**CHANGE
REQUEST
NO. ILC-CR-NNNN**

[ORIENTATION OF ELECTRON/POSITRON LINACS]

Figure 1. Schematic layout of the ILC shown in TDR, but in the 250 GeV configuration.

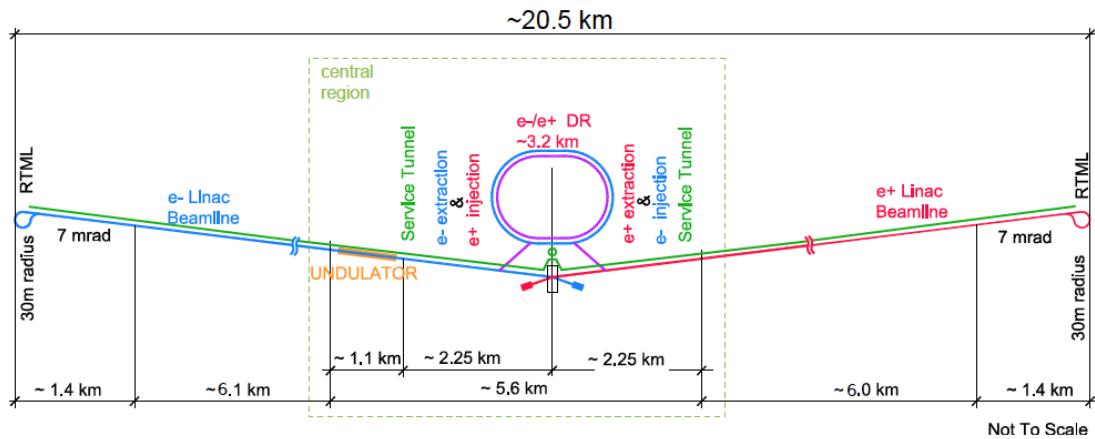
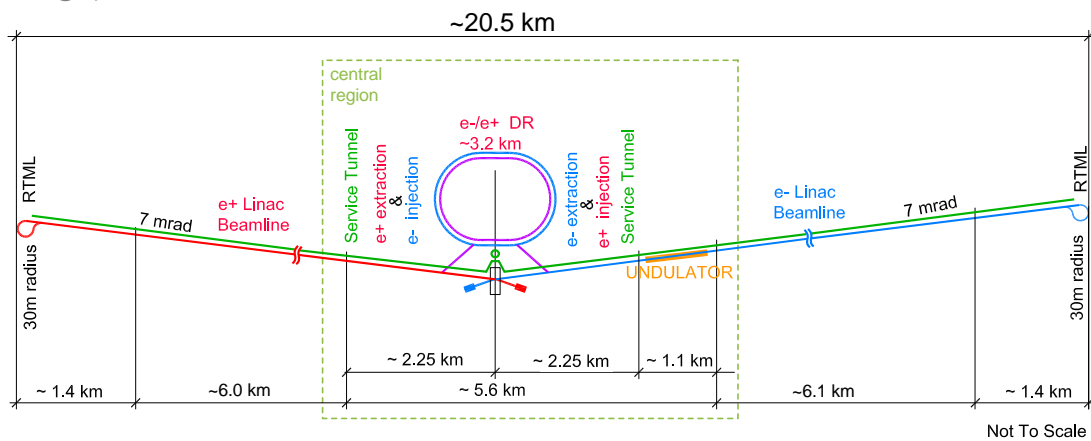
In the schematic layout of the ILC complex shown in TDR (Figure 2.1, TDR Volume 3.II), the electron linac is on the left side and the positron linac on the right side with the damping ring on the upper side as shown in Figure 1. The present change request is to flip the two main linacs, i.e., the electron- and positron-linac is on the right side and on the left side, respectively, with the damping ring on the upper side as shown figure 2.

The proposed site in Kitakami area is a granite area which is long in the north-south direction, therefore the main linac is to be constructed in the north-south direction. Since the elevation tends to be lower in the west side, all the portals of the access tunnels, as well as the damping ring, should be on the west side of the main linacs to minimize the total length of the access tunnels. Since the elevation tends to be higher in the north compared to the south, and the arrangement of the utility caverns is not symmetrical with respect to the interaction point, the total length of

access tunnels can be minimized by flipping the electron- and positron linacs. The current siting study suggests the total length of access tunnels would be minimized if the electron linac is on the north side and positron on the south side.

This change would not affect the current lattice design but should introduce the new coordinate system. All the drawings and lattice file would need to be rewritten with the flipped coordinate system.
